BAKERSFIELD CITY SCHOOL DISTRICT

Re: Project #22244.00-73-MD: Installation of concrete masonry walls, iron fencing and operable access gates at the perimeter of the District's Maintenance and Transportation yard

ADDENDUM 2:

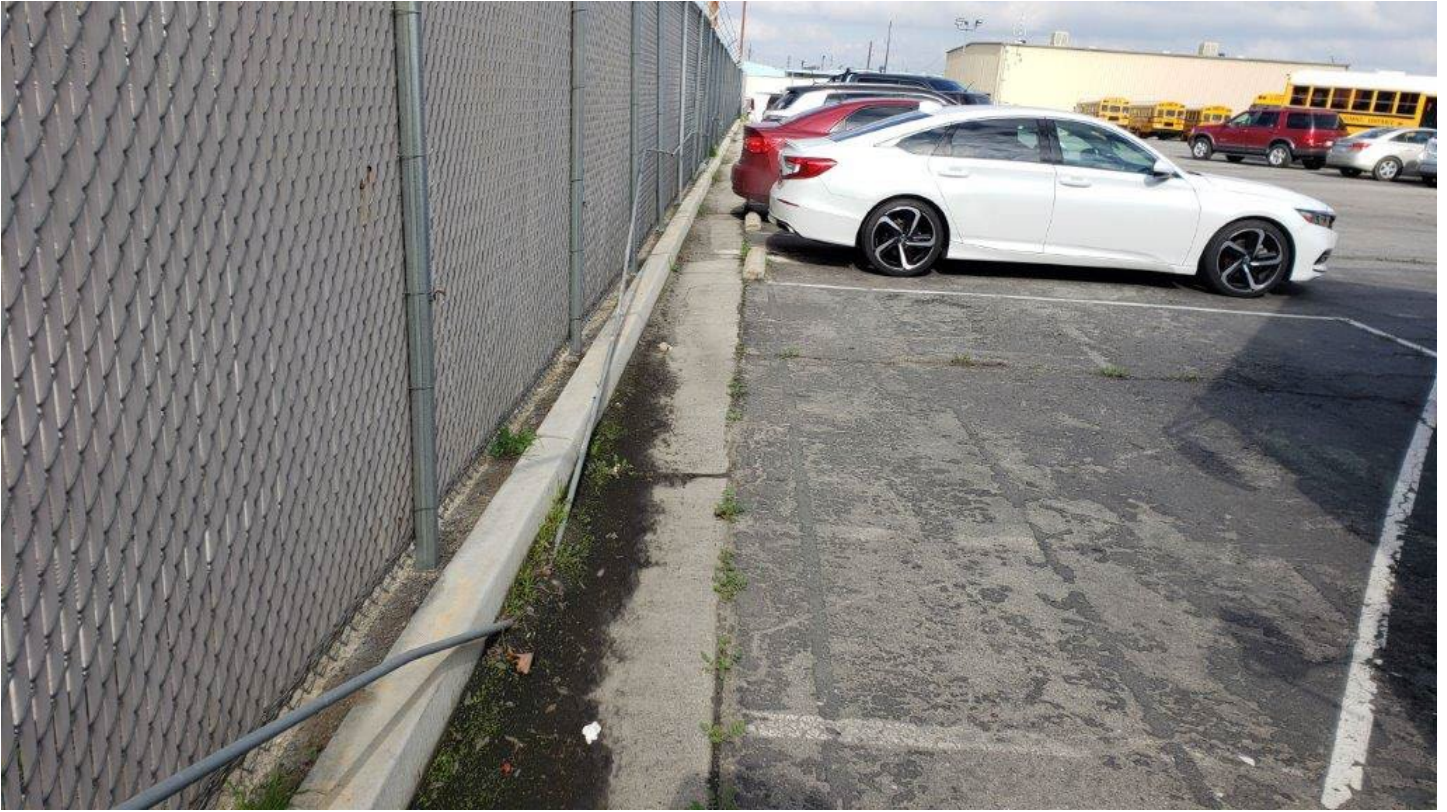
- Q15. There is an electrical conduit attached to the fence along the south wall next to the community services site. Please advise if this conduit can be removed. If not and it has to be reinstalled please advise where it comes from, goes to, wires that need to be reinstalled, etc. **Answer. The abandoned conduit will be removed by the district prior to contractor beginning this phase of the work. See attached pictures.**

Conduits to be removed by the district.

Conduits to be removed by the district.

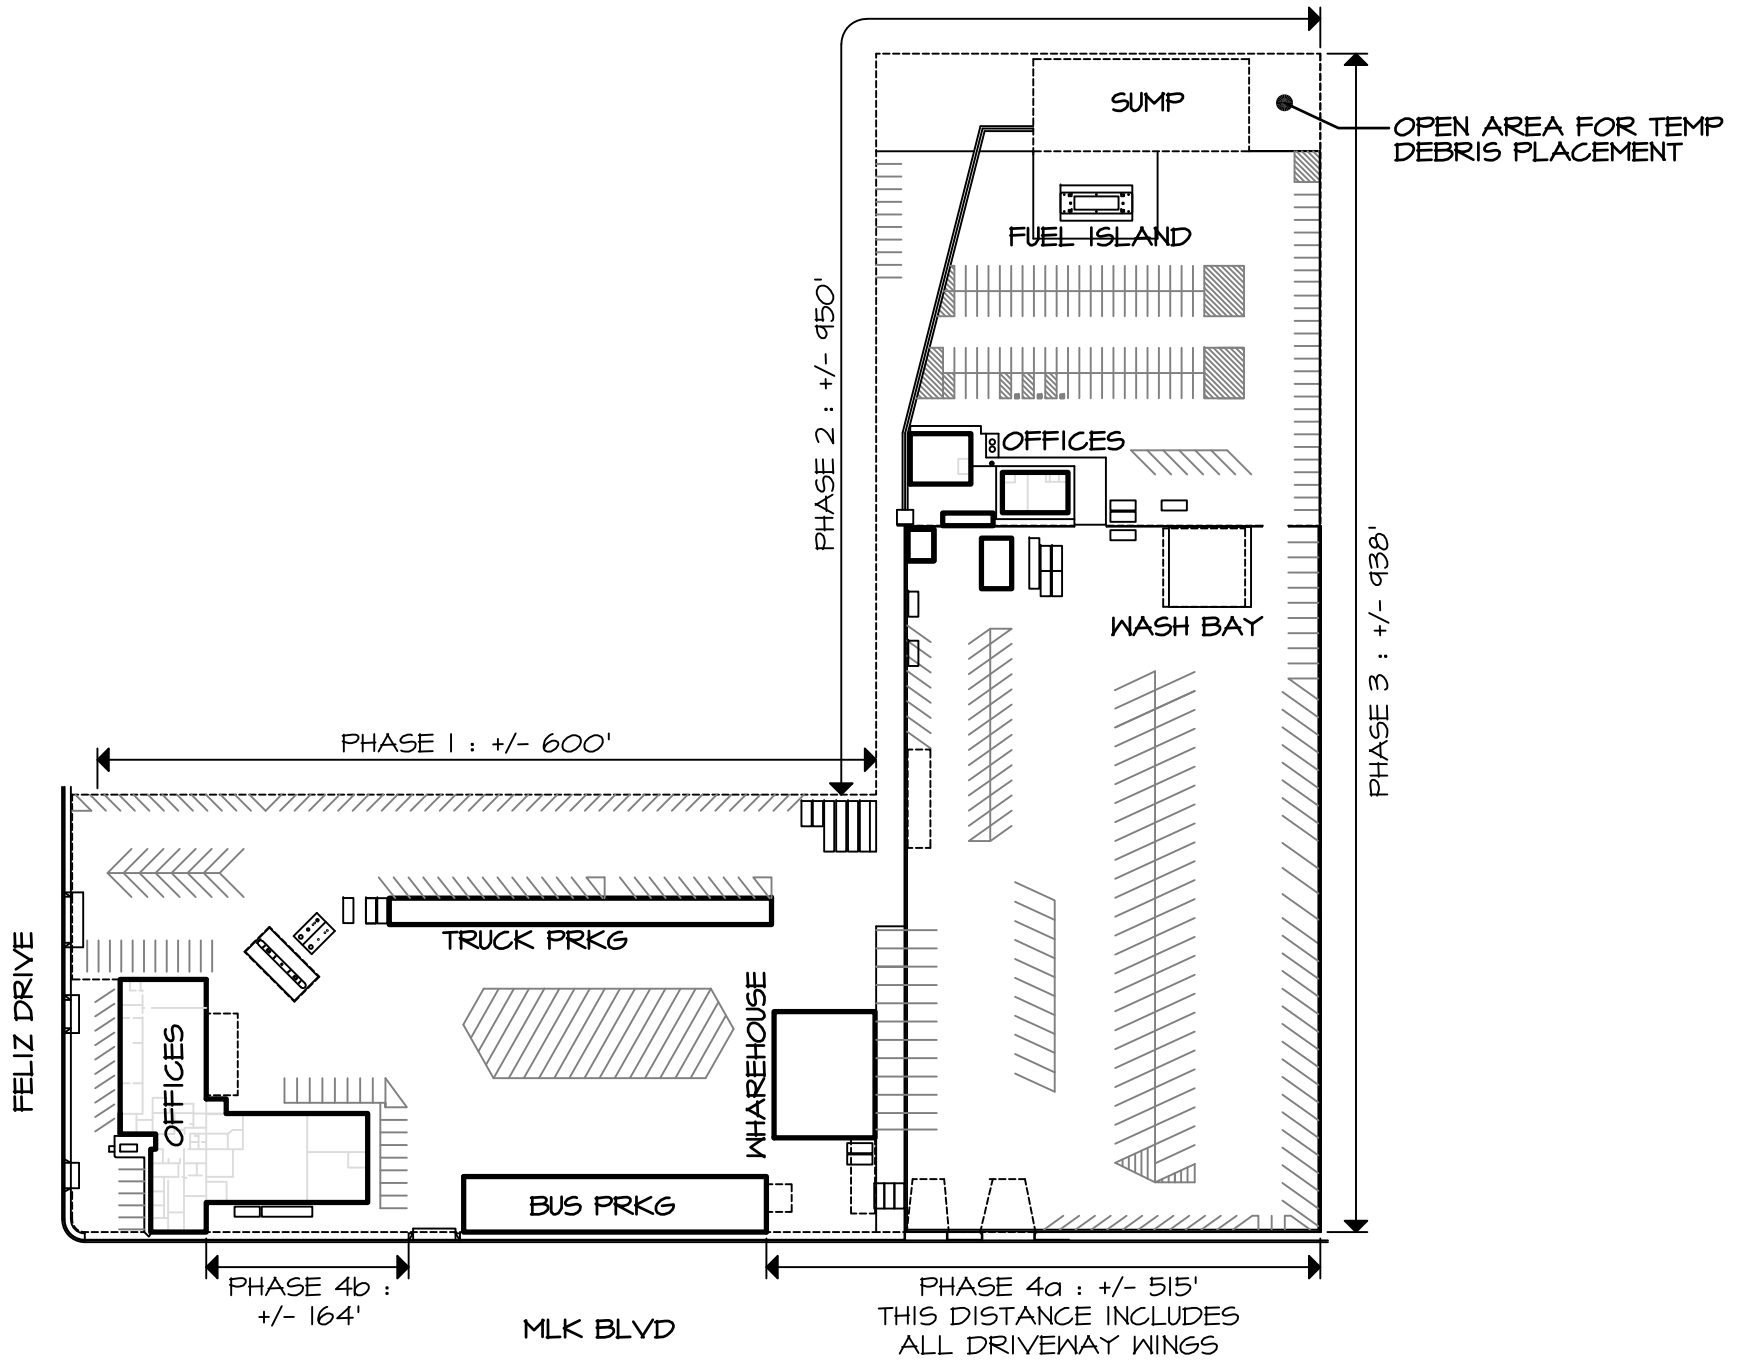
5. There is 6-8 inch diameter tree that has grown within the chain link fencing; approximately 25’ feet tall, and approximately 200’ east of MLK Blvd. that will need to be completely removed. See attached picture.

Tree within chain link fencing to be removed by contractors.

MOT YARD - OVERALL SITE PLAN
PHASING PLAN , 1-25-23

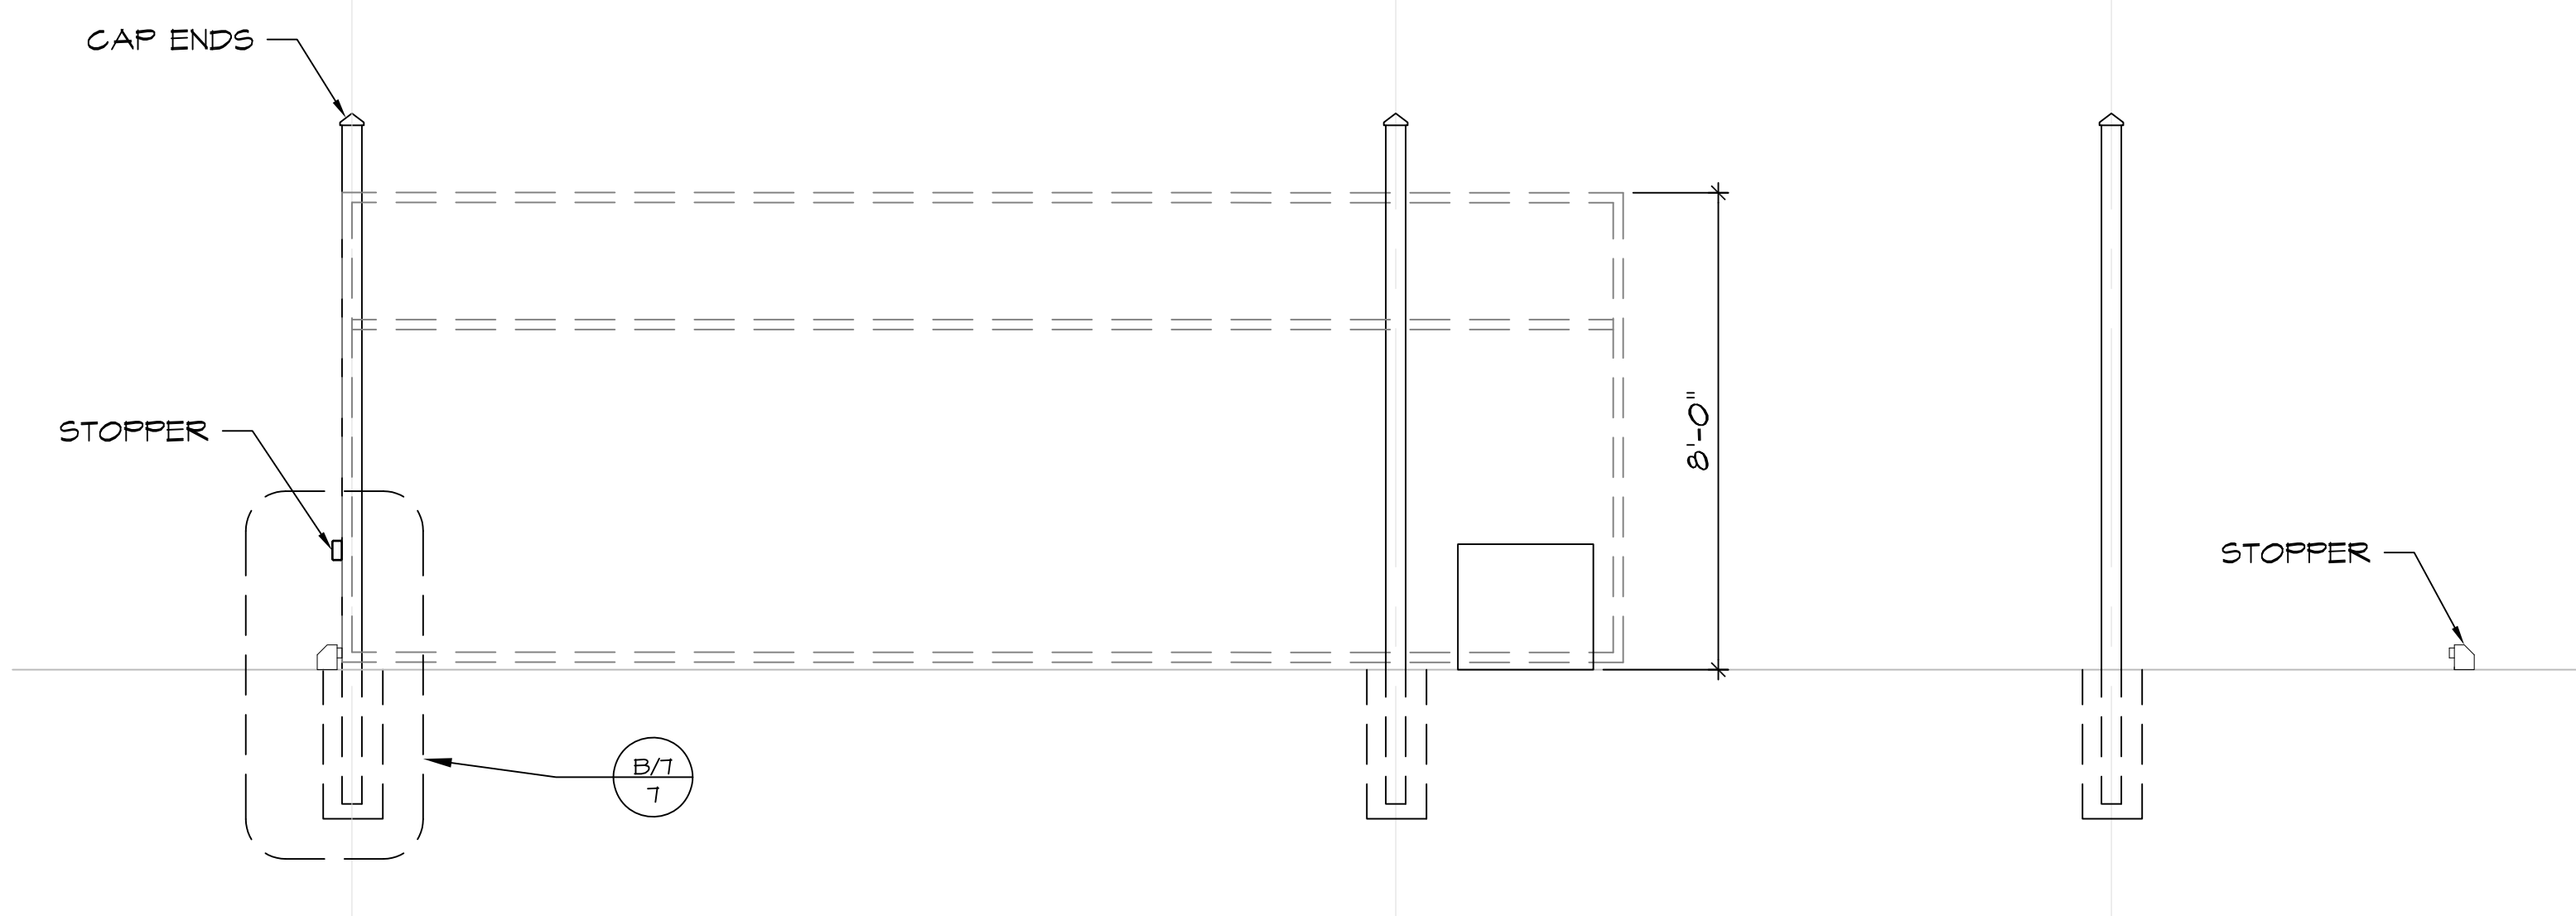
1. Construction shall be performed in four phases. See attached overall site plan for phasing locations. Construction days shall be revised to 222 calendar days based on the following schedule;

- Q7. Can the footing spoils be left somewhere on site or do they need to be hauled off? **There is a dirt area south of the sump in the southeast corner of the MOT facility that is available for temp placement of debris. See attached overall site plan for phasing and debris placement location. Removal of all debris will be required after each phase of wall construction.**
